27 March 2018  
EIR Reference: E0003613

I am writing in respect of your request of 19 February 2018 for the release of information held by the Civil Aviation Authority (CAA), and I am sorry for the delay in our response. Having considered your request in line with the provisions of the Environmental Information Regulations 2004, we are able to respond to your specific requests below.

**From:** [REDACTED]  
**Sent:** 10 June 2015 14:58  
**To:** [REDACTED]  
**Cc:** [REDACTED]  
**Subject:** FW: LAMP Phase1A Module-E

**From:** [Redacted]  
**Sent:** 01 June 2015 15:54  
**To:** [Redacted]  
**Cc:** [Redacted]  
**Subject:** LAMP Phase1A Module-E  
**Importance:** High

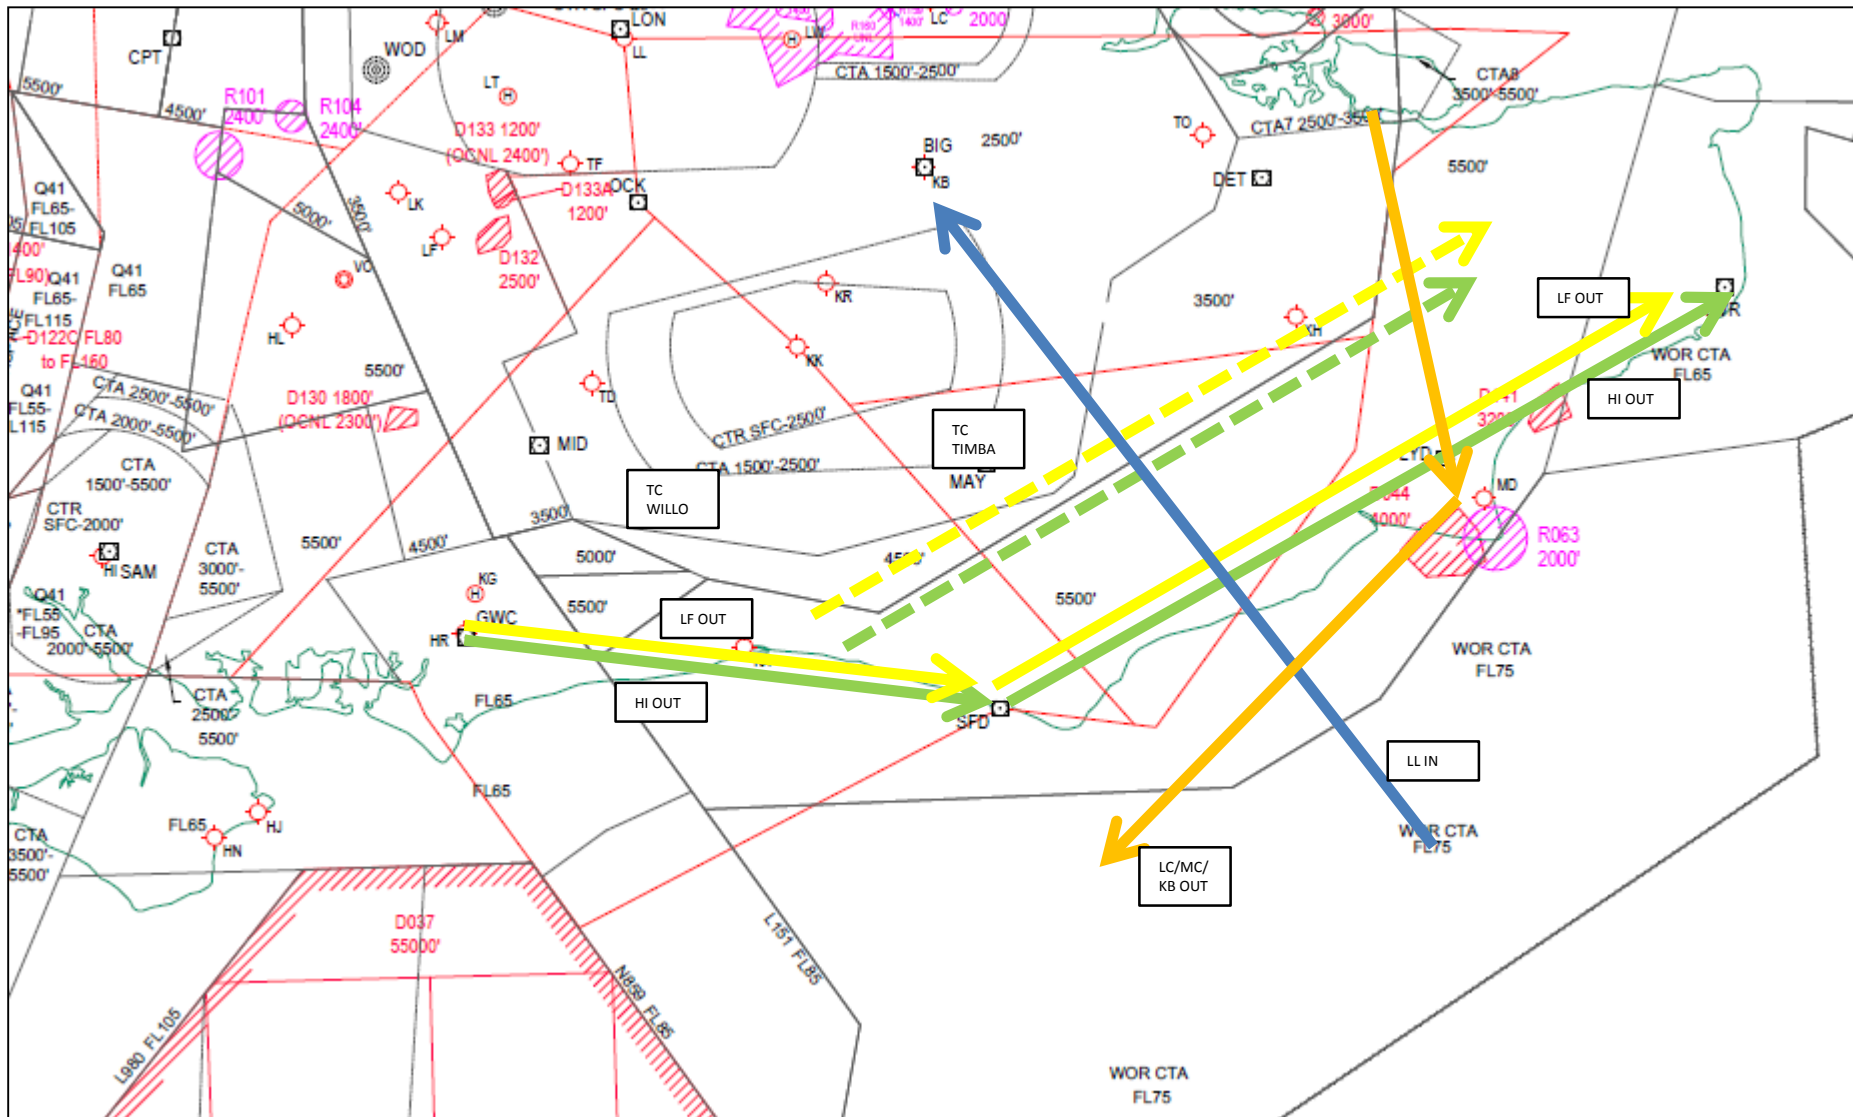
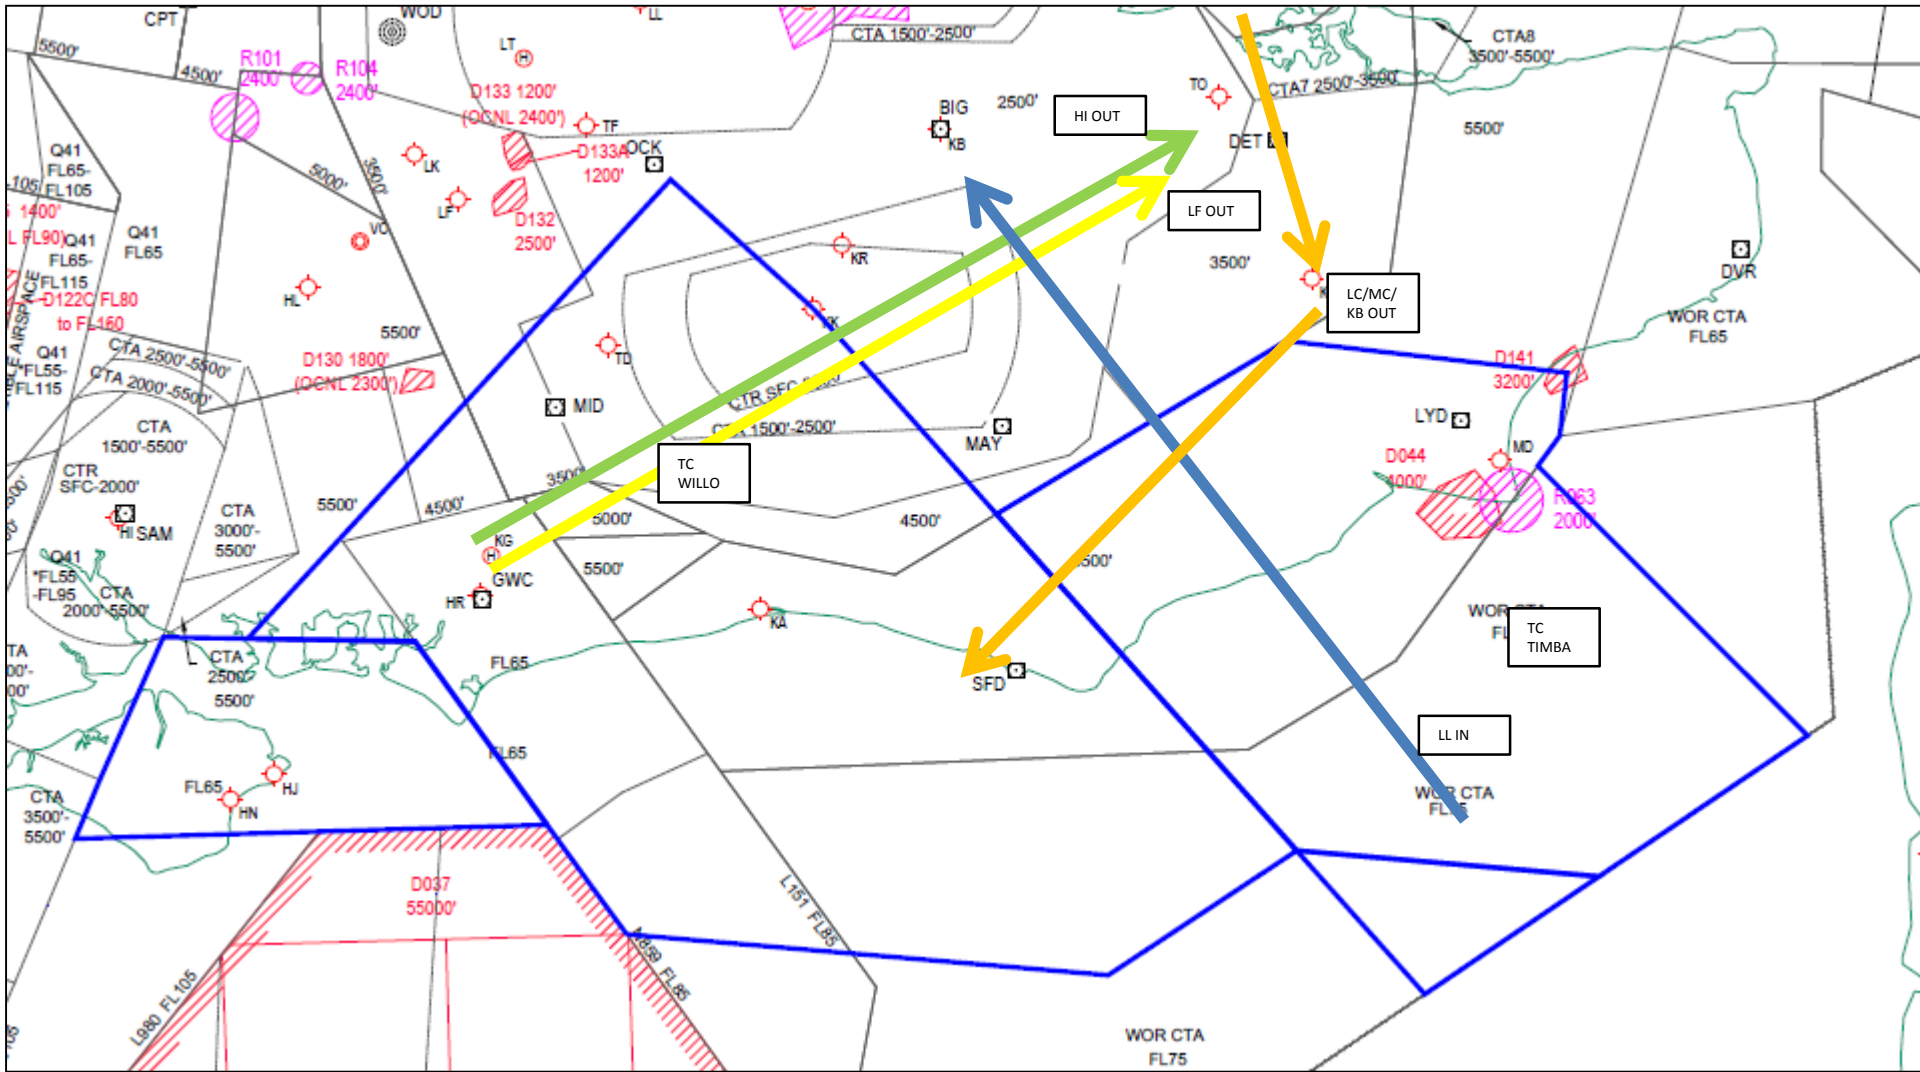
**Today.** TC Sth boundary in Red. LF and HI Deps climb from TC WILLO to S18 9not shown). S18 climb to FL190 and give to S17 (not shown) who then generally jump the LL arrivals by vectoring north of track (dashed green/yellow lines) to get away from the LL arrivals as their profiles are the same where their flight planned routes cross . These LF and HI departures outclimb the LC/MC/KB deps via LYD which have been held down low for miles by Thames. This is currently all S17's job. The LF/HH and HI avoid TC TIMBA.

**LAMP 1a.** TC Sth boundary in blue. TC TIMBA much bigger and taking on chunk of S17 task. The new LC design gets LC arrivals higher, quicker allowing TC TIMBA to cut them across ahead of LL arrivals. This would put them head on to LF/HI/HH deps if left via SFD as today: both reaching the SFD/MAY area at the same height.

If we left the LF/HI/HH deps as today they would therefore have to be held down low, underneath LL arrivals and be as low as FL190 as they approach DVR (rather than at cruise). Not only is this restrictive in terms of levels and penalising in terms of fuel and CO2, it would also add complexity to the enlarged TIMBA sector that is disproportionate to the average of c.7 LF/HI/HH flights a day as they would perpendicular to the primary LL arrival flow through the sector, and seeking climb. Note also that c.7 per day is an average number – the complexity would increase on days when there are more flights and/or when they happen to be during times that TC TIMBA is already busy.

# LAMP1a

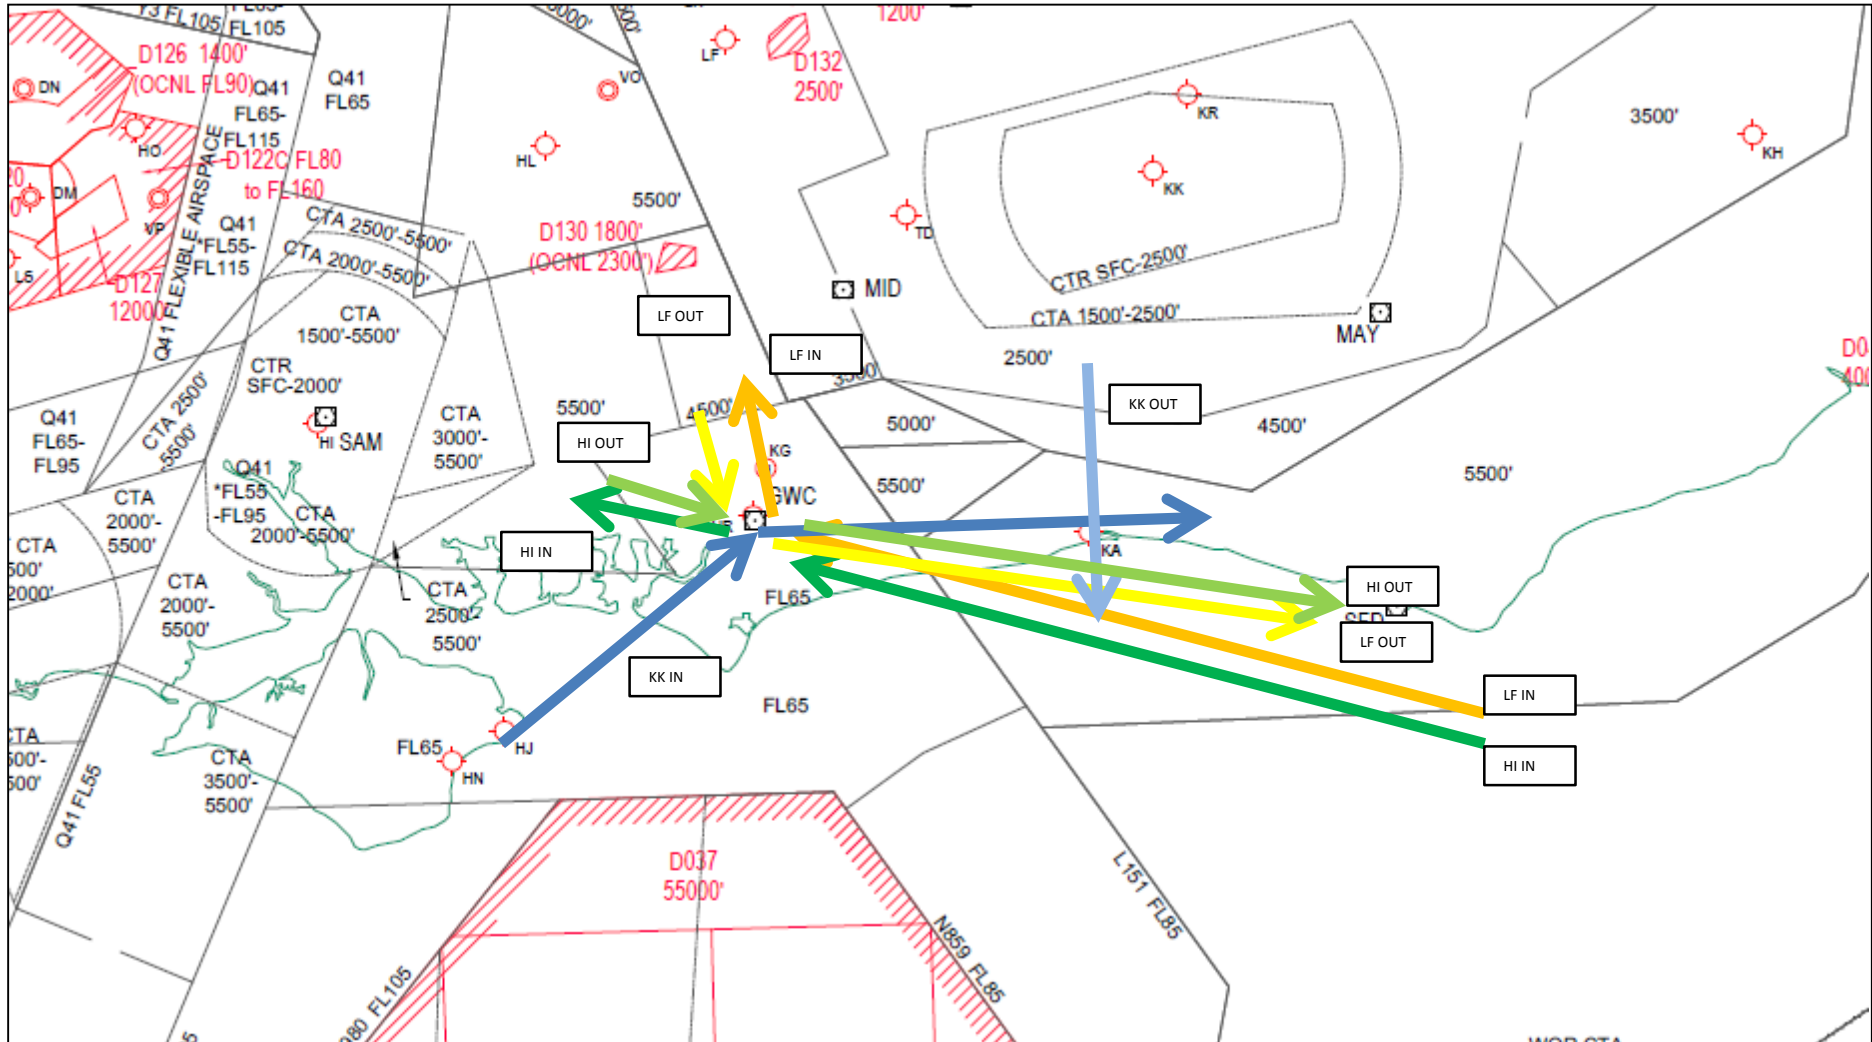
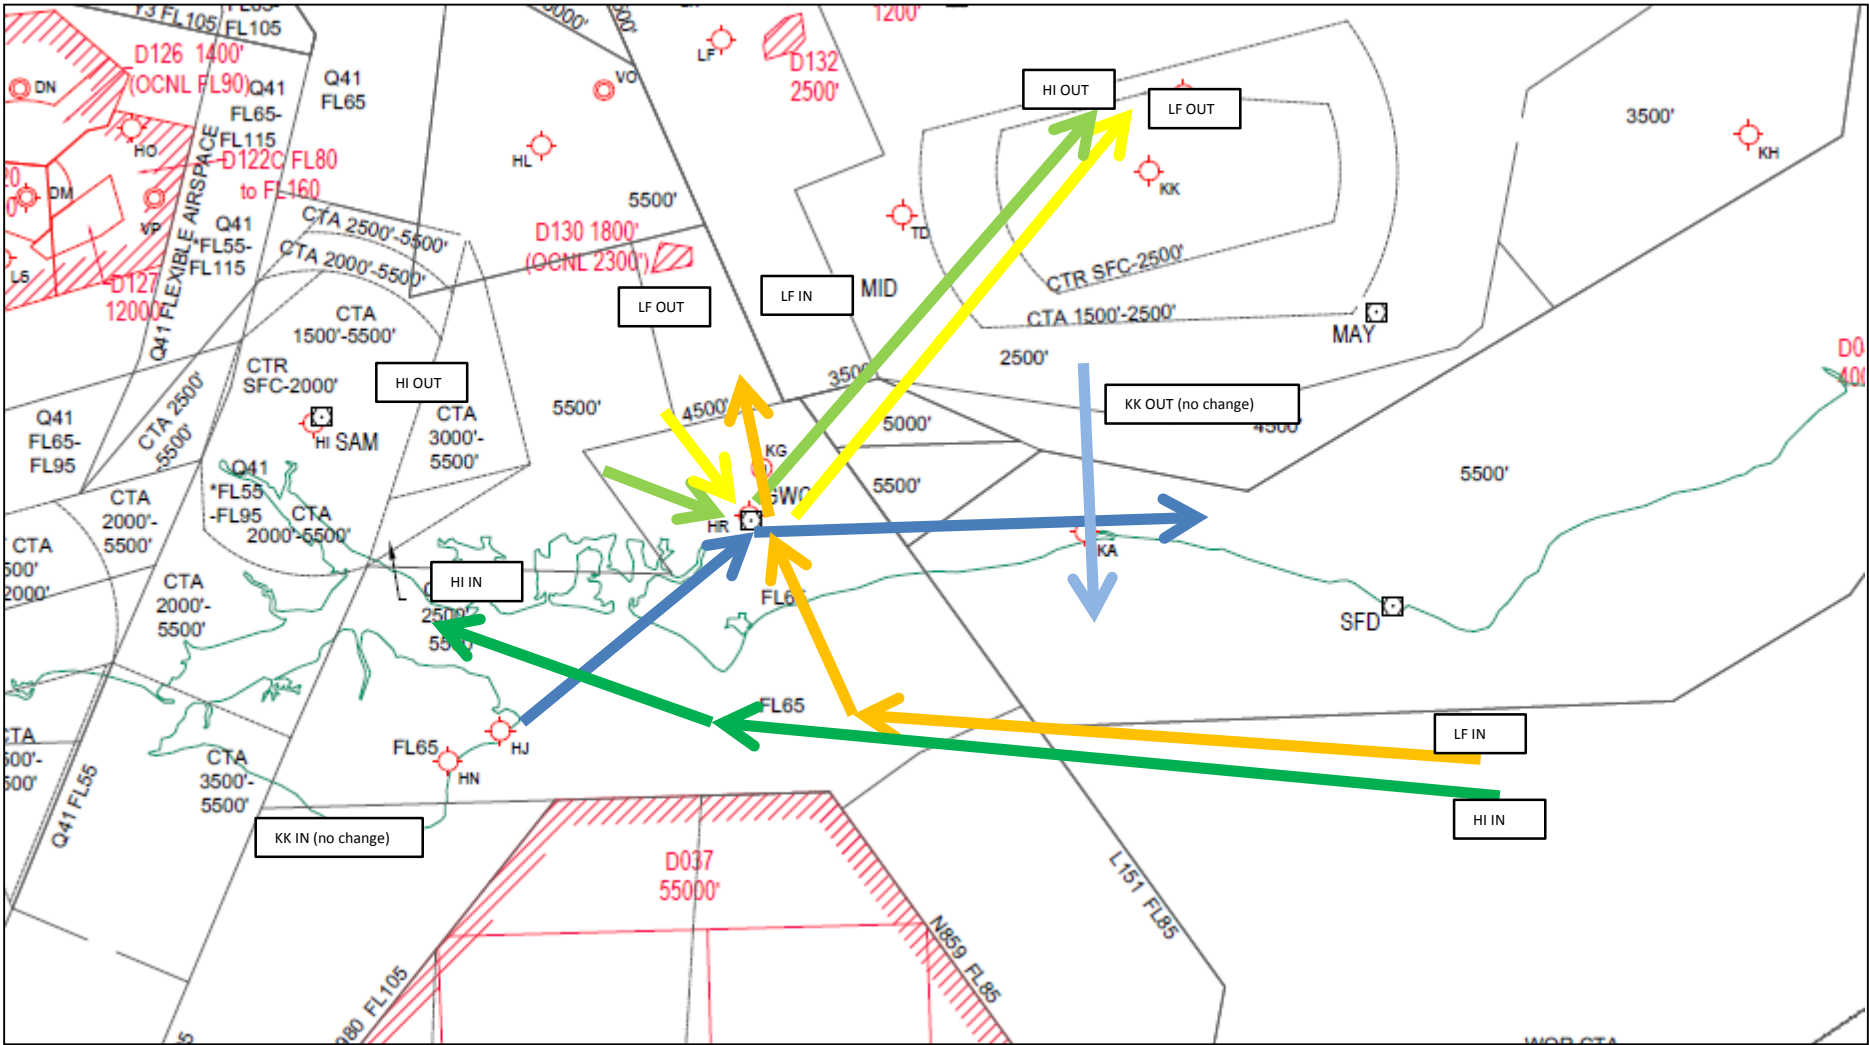
TODAY (ignore FL65 base in IOW area)  
 Everything converges at GWC and SFD

Helps to de-conflict all these routes in TC WILLO
